From: Pederson Ronda M (AREVA NP INC) [Ronda.Pederson@areva.com]
Sent: Friday, May 29, 2009 9:49 PM
To: Getachew Tesfaye
Cc: BENNETT Kathy A (OFR) (AREVA NP INC); DELANO Karen V (AREVA NP INC); VAN NOY Mark (EXT)
Subject: Response to U.S. EPR Design Certification Application RAI No. 155, Supplement 3
Attachments: RAI 155 Supplement 3 Response US EPR DC.pdf

QUESTIONS for Structural Engineering Branch 2 (ESBWR/ABWR Projects) (SEB2)

Question 03.08.01-8:

Figure 03.08.01-10-1—ANSYS Finite Element Model of Containment (2 Degree Slice) with Axisymmetric Boundary Conditions and Internal Pressure (red arrows)

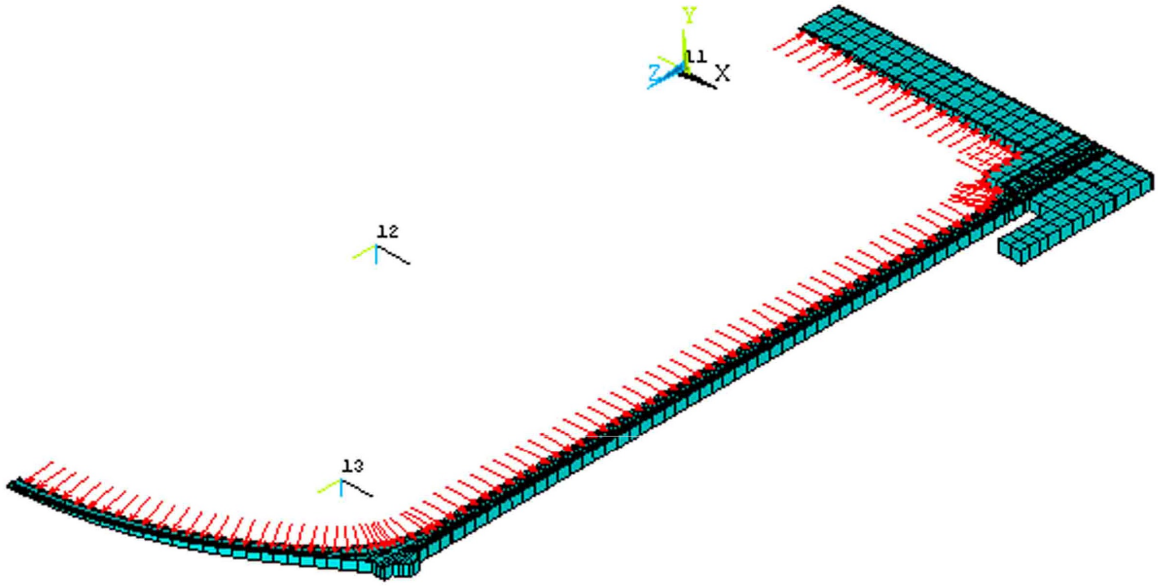
2. FSAR Section 3.8.1.4.11 indicates that the pressure capacity for various structural elements were based on the median pressure capacity. As discussed under item 1 above, the containment ultimate pressure capacity should not be determined on a probabilistic basis. Provide the containment ultimate pressure capacity for the various containment elements on a deterministic basis in accordance with SRP 3.8.1.II.4.K, or provide the technical basis for alternative criteria.

3. To support the results presented in FSAR Table 3.8-6, provide a description (including figures) which summarize and show: the models, material properties and material modeling, computer codes, loading sequences, tendon relaxation effects, concrete shrinkage & creep, potential failure modes, assumptions, and results.

displacement option turned on in ANSYS. The finite element mesh is shown in Figure 03.08.01-10-1.

Figure 03.08.01-10-2—Equipment Hatch ANSYS Finite Element Model

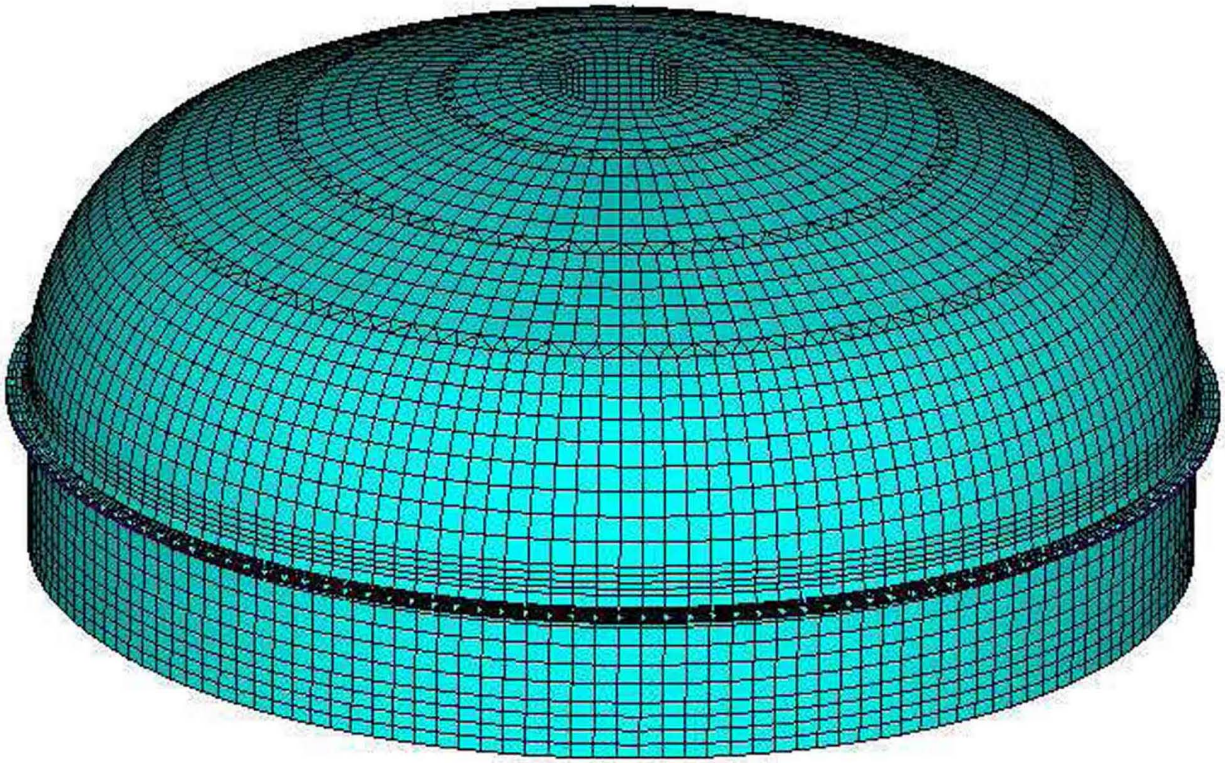
6. In addition to the structural integrity calculations, how was leakage from the various containment elements (e.g., penetrations, bolted connections, seals, hatches, bellows) evaluated and what leakage acceptance criteria were utilized to verify the final ultimate capacity of the containment?

The ANSYS non-linear finite element analysis is performed for the equipment hatch evaluation. SA516 Grade 70 steel is used for the hatch cover, flanges and sleeve in the analysis. The structure contains a hatch cover (of tore-spherical shape), a sleeve, and two flanges plus 40 clamps that link hatch and sleeve. The model used SHELL43 for hatch, flanges and sleeve (including protruding sleeve), CONTAC52 for contact between flanges, LINK8 for tightness joints and clamps, and PIPE16 to connect contact flange to the middle plane. The equipment hatch FE-Model is shown in Figure 03.08.01-10-2.

Figure 03.08.01-22-1—Location of the Selected Sectors in Containment Slice Model

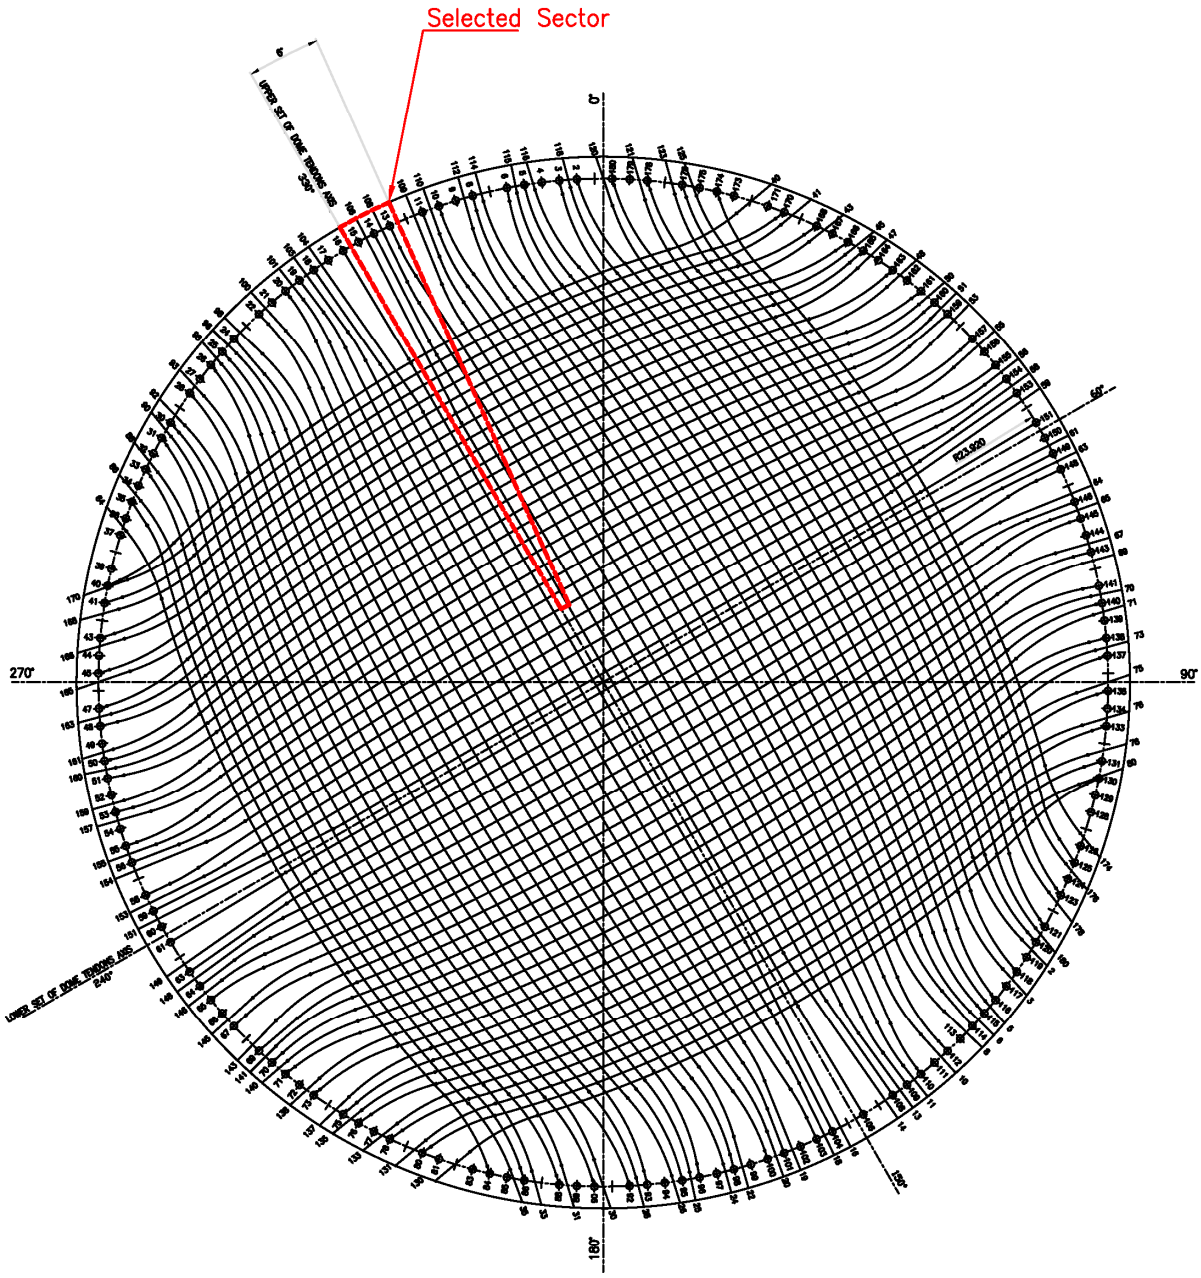
FSAR Section 3E.1.1 and other sections of Appendix E state that a separate analysis was performed to estimate the effects of cracked concrete and based on the results of the analysis the thermal moments carried by portions of the RCB were reduced. Describe the analysis performed including a description of computer codes, identify other concurrent loads that were considered in the analysis, the method used for reducing the thermal moments, how the final design loads were determined, and identify the portions of the RCB where this was done. Provide a similar description for the treatment of thermal moments in FSAR section 3.8.3, 3.8.4, and 3.8.5. Include in this discussion under what conditions these moments were considered and where in each structure thermal moments were reduced.

A calculation was performed to evaluate the change in magnitude in thermal moments in prestressed concrete containment model resulting from mesh refinement and cracking of the concrete section. The analysis was performed with finite element program ANSYS 11.0 (Service pack 1).

- A typical sector of the containment away from the discontinuities is identified and shown in Figure 03.08.01-22-1. A 6° slice of the containment is selected for study.

- This equivalent slice model is further refined for the mesh density to calculate the change in thermal moments due to mesh refinement. This “refined slice model” is solved for thermal loading only.

- Comparison of thermal moments between the equivalent and refined slice models provides the thermal modification factor due to mesh refinement.
- This linear slice model is converted to nonlinear slice model by changing the SOLID45 elements to SOLID65 elements allowing cracking as well as considering reinforcement.

Figure 03.08.02-6-1—Medium Voltage Electrical Penetration

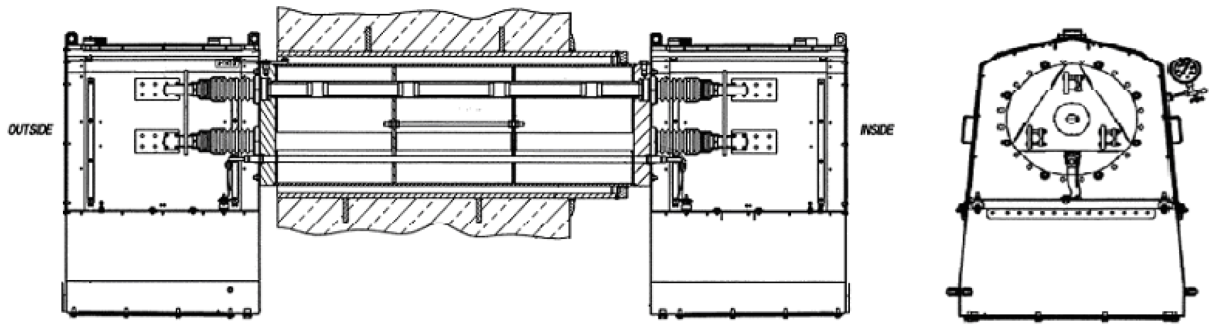
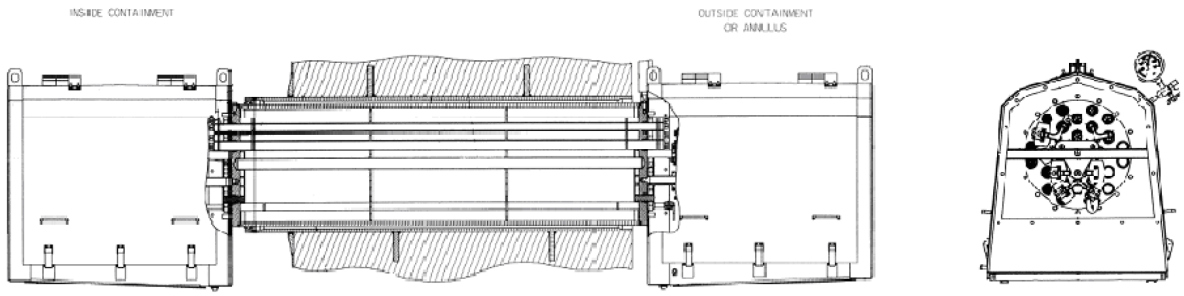
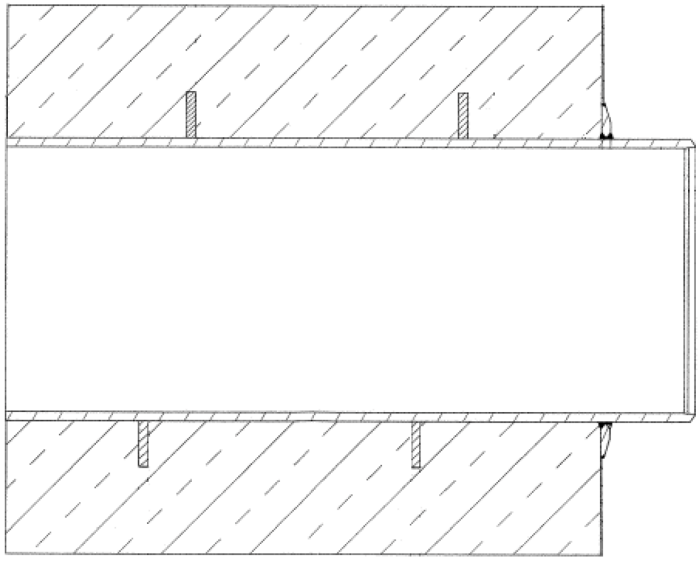
GDC 16 requires that reactor containment and associated systems shall be provided to establish an essentially leak tight barrier against the uncontrolled release of radioactivity. FSAR Section 3.8.2.1.3 discusses electrical penetrations through the containment boundary. What qualification and testing will be done, or has been done, to assure that electrical penetrations will meet the requirements of GDC 16 and will withstand the pressure and temperature conditions under the design basis accident? Provide details of the electrical penetrations including any spares.

Figure 03.08.03-11-1—Boundary Between Containment Structure and Crane Assembly

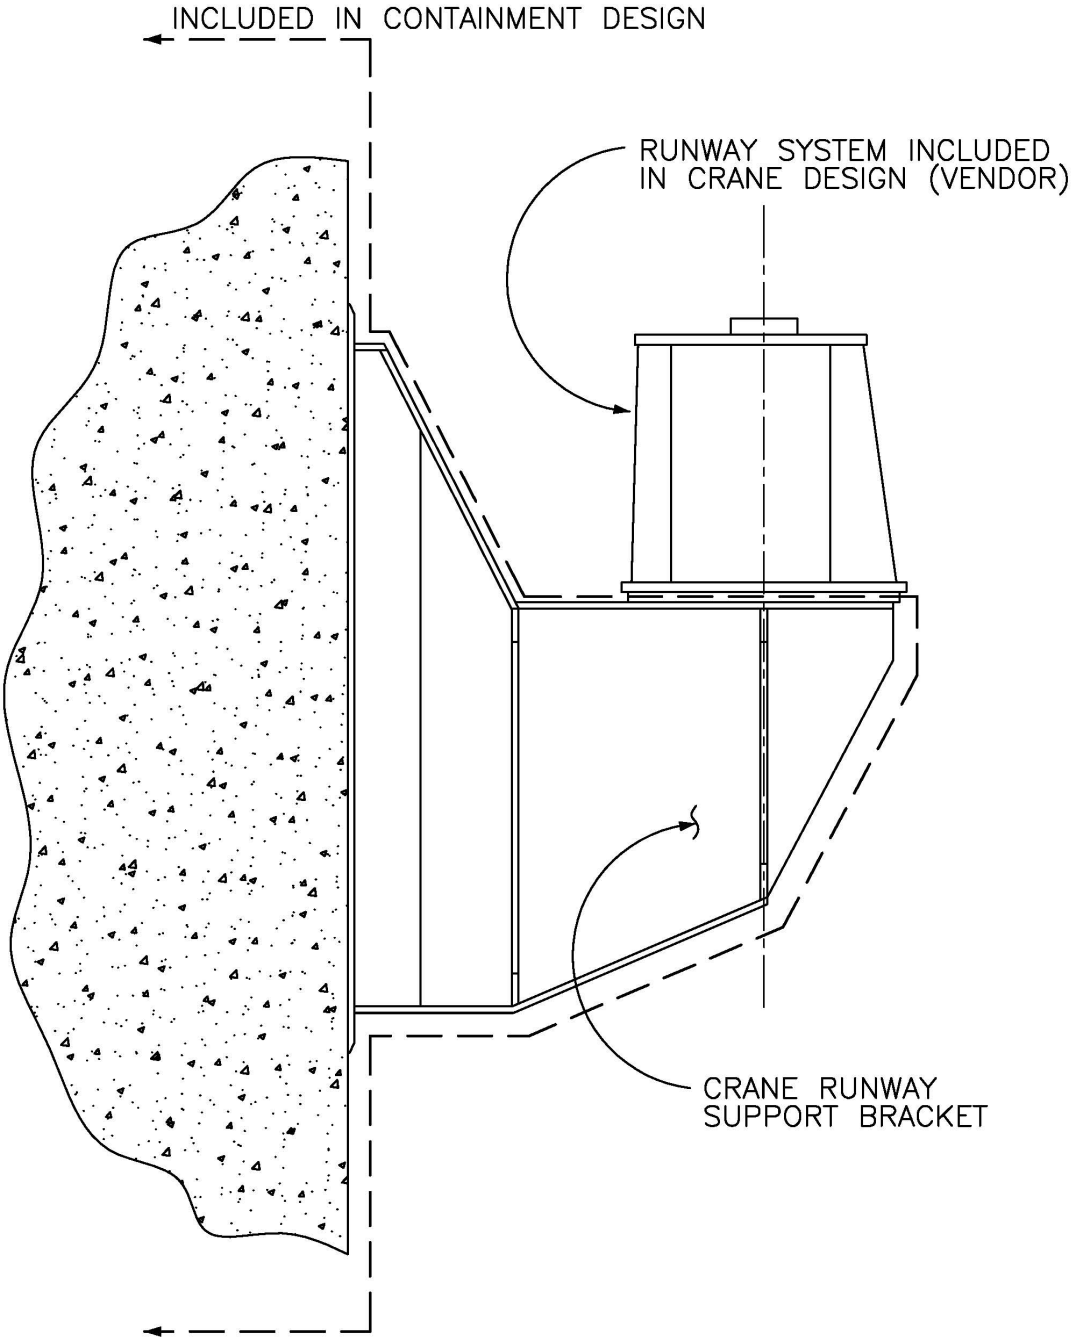
FSAR Section 3.8.3.1.8 provides a brief description of the polar crane support structure and FSAR Section 3.8.3.4.4 provides a description of the development of polar crane seismic loads. Since these descriptions are presented in FSAR Section 3.8.3, provide the following information:

1. Explain what structural members are considered to be within the scope of containment internal structures. Provide a detail showing the boundary of these structural members and the crane assembly, and the jurisdictional boundary between these structural members and the RCB.
2. Describe the analysis methods including computer codes that were used to analyze and design these intervening structural members between the polar crane assembly and the RCB wall.
3. Provide the materials and design codes that were used for the crane girder and the intervening structural members.

1. The polar crane support brackets (steel) are included in the design of the containment vessel. The boundary between the brackets and the crane is the location at which the crane runway support system (girders) attaches to the brackets. A detail showing this interface (boundary) is provided in Figure 03.08.03-11-1.

The polar crane brackets are included as part of the containment ANSYS model. This is done to provide locations for transfer of the loads from the polar crane into the containment structure.

Figure 3.8-106—Elastic Displacement for Soil Case 1u

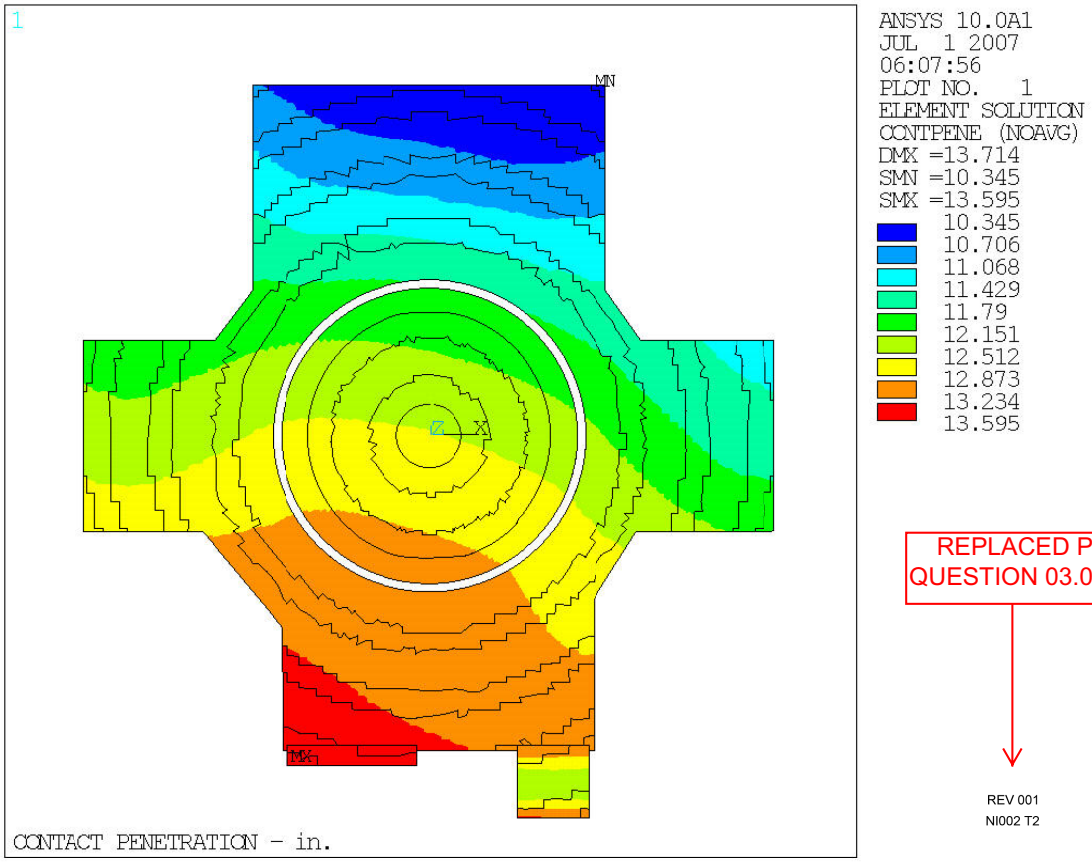
3. FSAR Figure 3.8-106 does not appear to provide the elastic displacement for soil case 1u. This information should be provided similar to Figures 3.8-107 through 115.

3. The U.S. EPR FSAR Tier 2, Figure 3.8-106 will be revised.

U.S. EPR FSAR Tier 2, Figure 3.8-106, will be revised as described in the response and as indicated on the enclosed markup
